DESCRIPTIVE REPORT

Type of Survey HYDROGRAPHIC

Registry No. H-11191

Sublocality Jack Bay to Castle Bay

Figure 1 H11191 Survey Limits

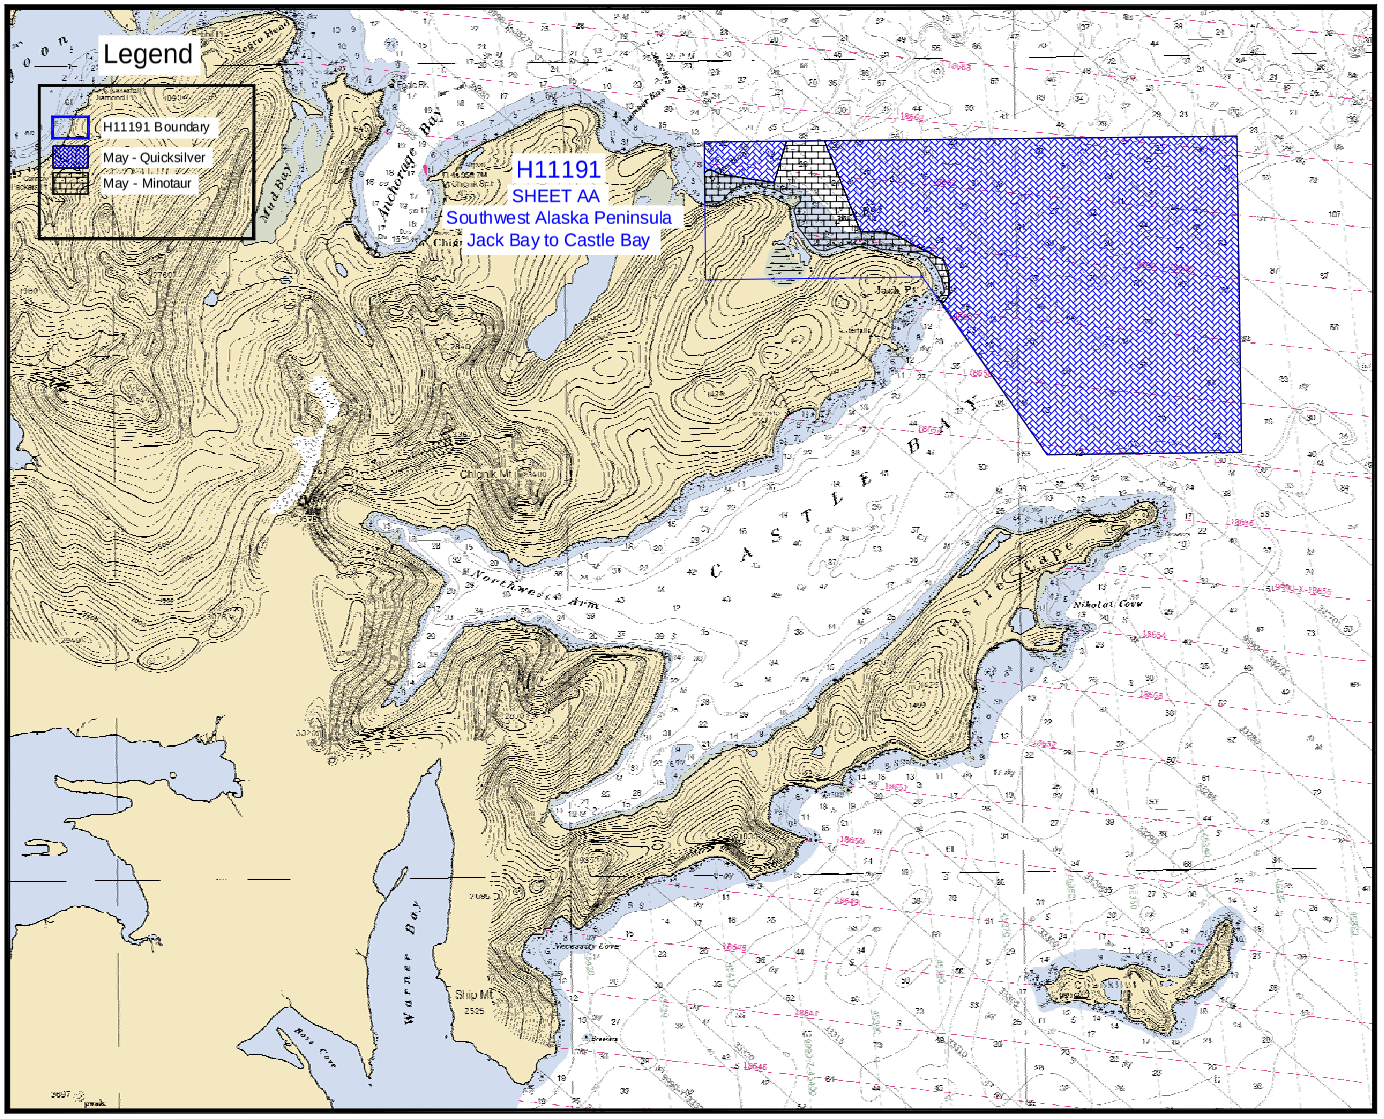
H11191 (Sheet AA), is bounded by the coordinate listing below, and encompasses Jack Bay to Castle Bay.[1]

Survey Limits[2] Task Order # 11 H11191 Sheet AA Scale 1:10,000		
Point #	Positions on NAD83	
	Degrees Latitude (N)	Degrees Longitude (W)
1	56º19’00.210” N	158º05’03.351” W
2	56º19’00.210” N	158º16’52.615” W
3	56º17’19.398” N	158º12’04.283” W
4	56º15’06.996” N	158º09’21.782” W
5	56º15’06.919” N	158º05’03.361” W
6	56º19’00.210” N	158º05’03.351” W[3]

[1] Concur.
[2] Concur with clarification. The approximate limits of hydrography are:
- Lat 56/19/12N and Lon 158/17/3W
- Lat 56/14/55N and Lon 158/9/32W
- Lat 56/14/55N and Lon 158/4/26W
- Lat 56/19.12N and Lon 158/4/26W

[3] Concur with clarification. Point 6 is the same position as Point 1.
[4] Filed with the project reports.
[5] Strikethrough ~~was~~, replace with "were".
[6] Strikethrough ~~was~~, replace with "were".
[7] Strikethrough ~~1~~, replace with "4".
[8] Strikethrough ~~versus~~, replace with "combined with".
[9] Concur. H11191 is adequate to supersede all prior surveys and miscellaneous source data except as noted in this report and the Hdrawing.
[10] Strikethrough ~~Northeast~~, replace with "Southwest".
[11] Strikethrough ~~North~~, replace with "South".
[12] Concur. In PHB processing, H11191 was also compared at its eastern junction with H11021 (OPR-P182-RA, 2002). The data showed excellent correlation, generally to within less than 1 fathom.
[13] Strikethrough ~~5~~, replace with "6".
[14] Strikethrough ~~it is apparent on these examinations the transition from phase to amplitude detection method of the sonar (around beams 26 and 71) and any errors due to sound velocity~~, replace with "the transition from phase to amplitude detection method of the sonar (around beams 26 and 71) and any errors due to sound velocity are apparent".

Figure 4: Navigation Error With Respect to Slope

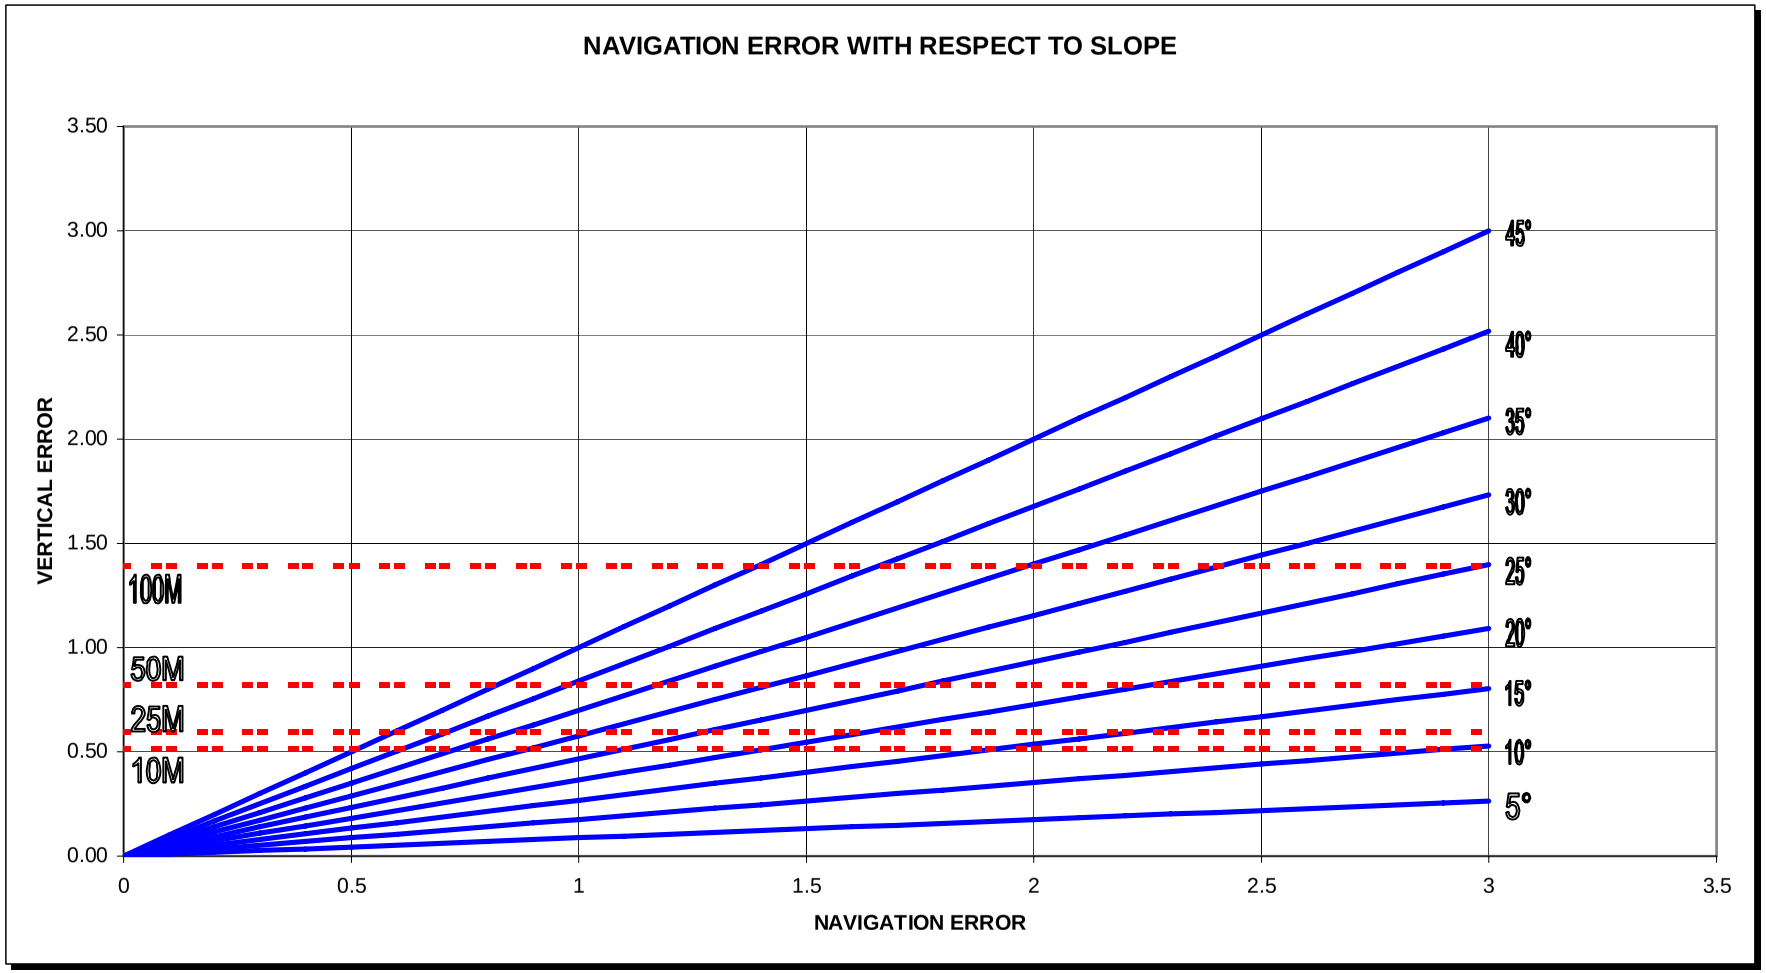
- The accuracy of a typical DGPS unit is between 1 to 3 m, and with the constant coming and going of satellites in these areas; it was not uncommon to get a 1 to 3m-navigation jump. Although this is well within the NOS specifications, Figure 1[7] shows graphically how navigation error versus[8] vertical error can rapidly affect the specified accuracy. For example, with a 1.5m navigation error at a water depth of 25m, if the slope of the bottom is greater then 20º then the beams are outside of the 95 percent confidence level.

Figure 5 H11191 Survey Junctions

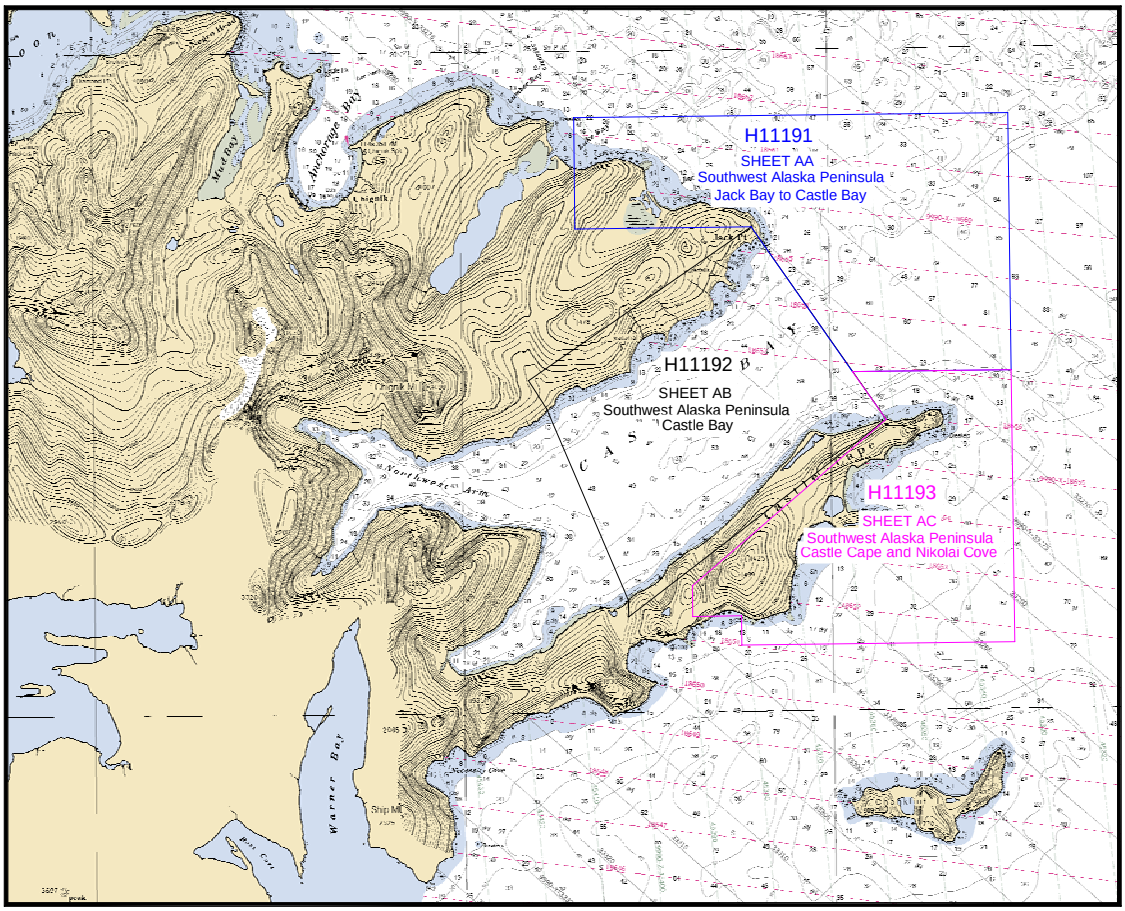
H11191 (Sheet AA) junctions with:

Registry #	Scale	Date	Junction Side
H11192	1:10,000	2003	Northeast[10]
H11193	1:10,000	2003	North[11]

The surveys are in agreement along their common borders.[12] The agreement was noted in the field using the 2-meter DTM's created for coverage verification. The conformity is also apparent in their preliminary smooth sheets.

Figure 6 Histogram for 8101 (Quicksilver)

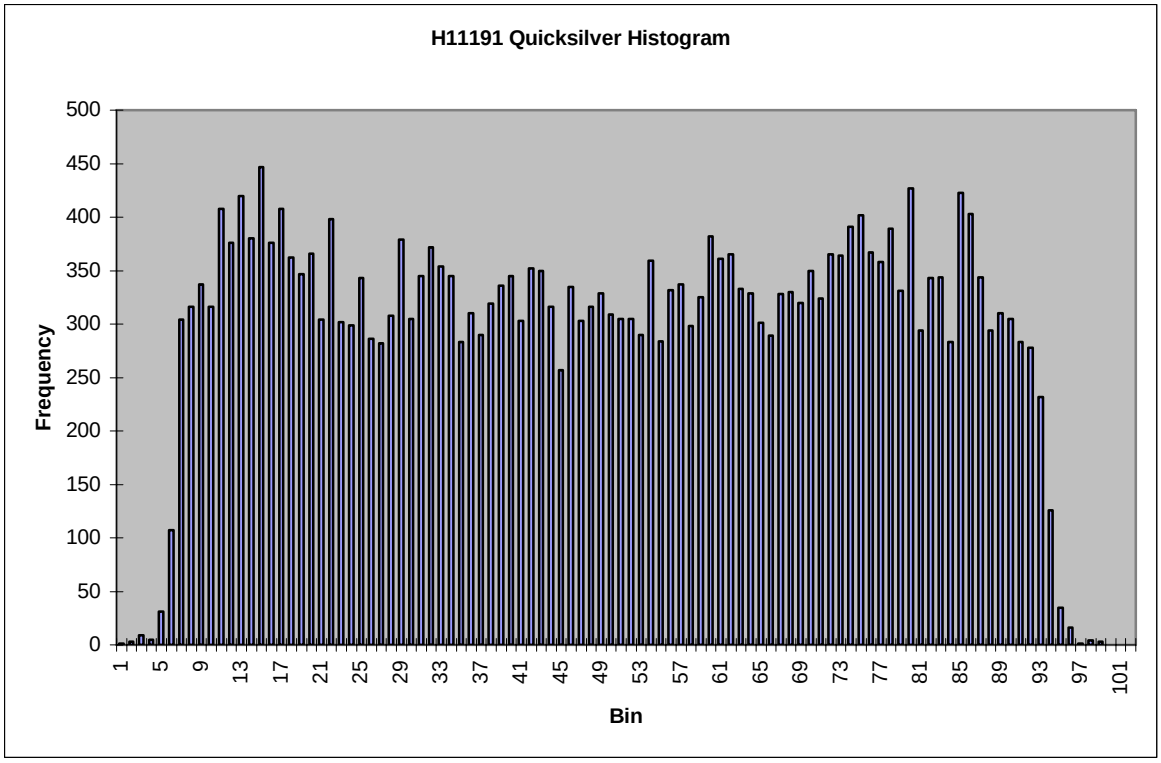
Figure 5[13] Histogram is for the Reson 8101 data collected from May 1, 2003 to June 6, 2003 on the Quicksilver. The histogram is evenly distributed, but it is apparent on these examinations the transition from phase to amplitude detection method of the sonar (around beams 26 and 71) and any errors due to sound velocity.[14] The decrease of selected soundings on the outer beams is the result of deterioration of data quality on the outer beams, especially in deep water. In most cases set filters were used to flag the outer beams as rejected, but in other cases additional cleaning or filters were used on a line by line bases[15] resulting in fewer selected soundings.

[15] Strikethrough ~~bases~~, replace with "basis".
[16] Strikethrough ~~6~~, replace with "7".
[17] Strikethrough ~~the majority of lines were run~~, replace with "in the majority of lines run".
[18] Strikethrough ~~those beams are~~, replace with "that beam is".
[19] Strikethrough ~~beams~~, replace with "soundings".
[20] Survey data is acceptable for charting.
[21] Strikethrough ~~the opposite direction~~, replace with "opposite directions".
[22] Strikethrough ~~where~~, replace with "were".
[23] Filed with the project reports.
[24] Also see Final Tide Note, Appendix D, attached to this report.
[25] In PHB processing, H11191 was also compared with Chart 16566, 11th Edition, continuous maintenance raster.
[26] Concur with clarification. The comparison of charted MHWL and nearshore features as shown in the hydrographer's Separate 6 (filed with the project reports) shows good correlation with charted shoreline and features. However, MHWL and nearshore features show discrepancies of up to approximately 80 meters from Chart 16566, 11th Edition,

Figure 7 Histogram for 8101 (Minotaur)

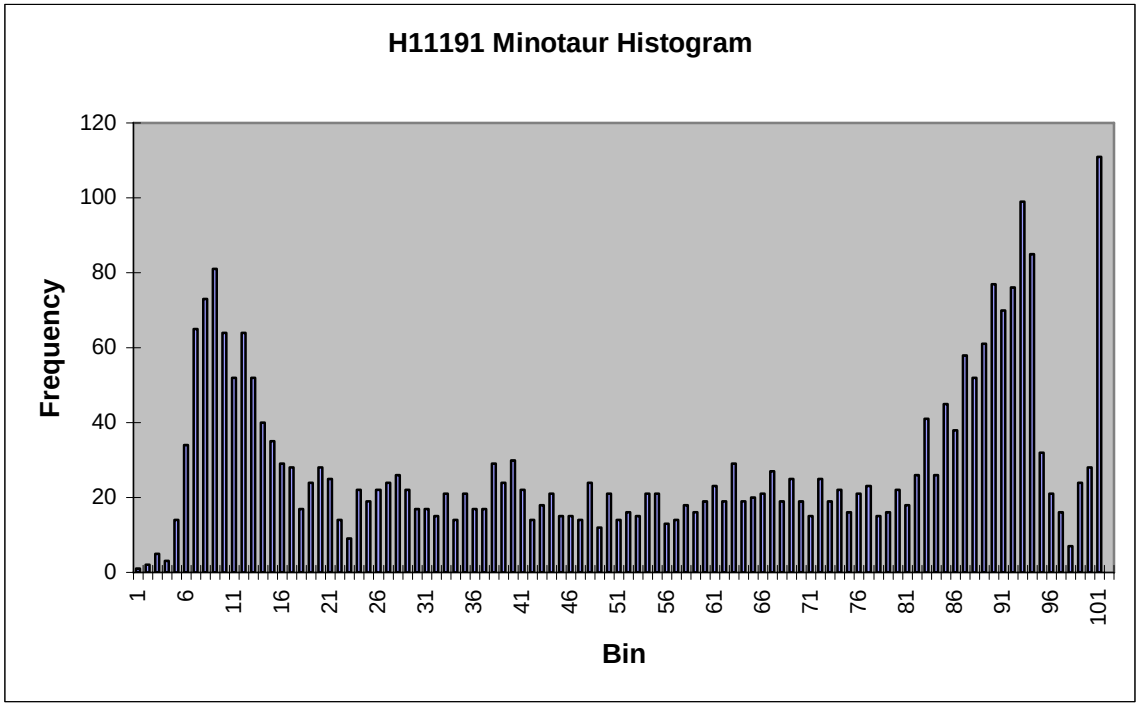
Figure 6[16] Histogram is for the Reson 8101 data, collected from May 8, 2003 to June 6, 2003 on the Minotaur. The histogram shows an increase on selected soundings from the outer beams. This is the result of surveying near the shoreline and the simple fact that the outer beams are the shallowest. Also the majority of lines were run[17], port beams overlapped with port beams and starboard beams overlapped with starboard beams from the adjacent lines. This makes it possible to have higher density data per square meter on the outer edges, leading to a higher chance of sounding selection on the smooth sheet.

This histogram also shows one distinct feature, which is the increase in the number of selected soundings from beam 101. This does not appear to be the result of equipment failure, survey or processing procedures. Inspection of the smooth sheet reveals trends where those beams are[18] shoaler than the rest of the profiles simply because it is up slope from all other soundings. The crossline comparisons revealed that these beams[19] were within IHO specifications; any differences were only a few centimeters.[20]

Figure 8 Comparison of Contours

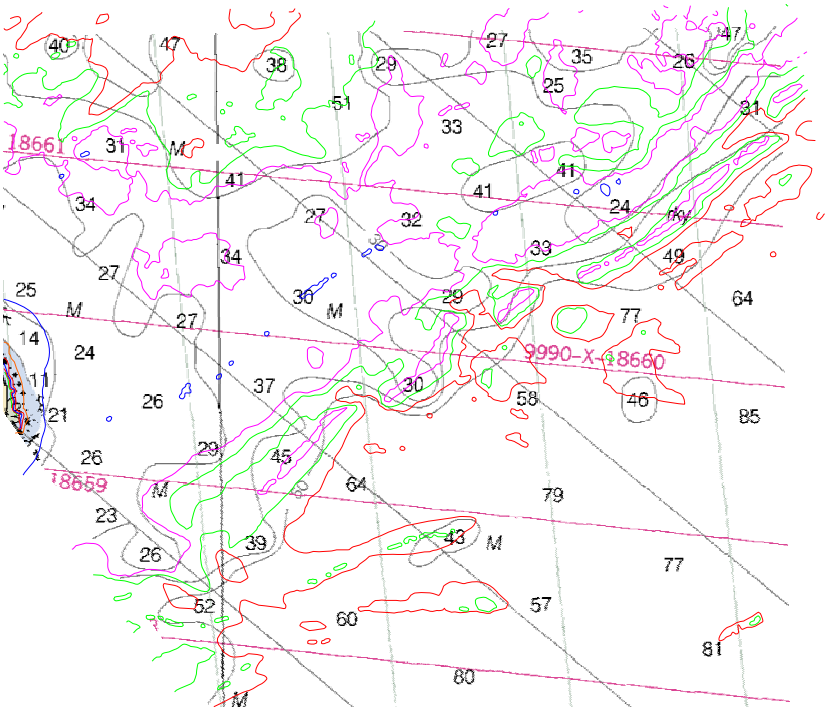
The near shore contours agree with the existing chart 16566, but the contours from H11191 bring forth much more detail of the seafloor in the offshore region, as seen in figure 8 below.[28]

[28] Concur. Contours have been generalized as warranted at chart scale on the Hdrawing. Chart according to the Hdrawing.
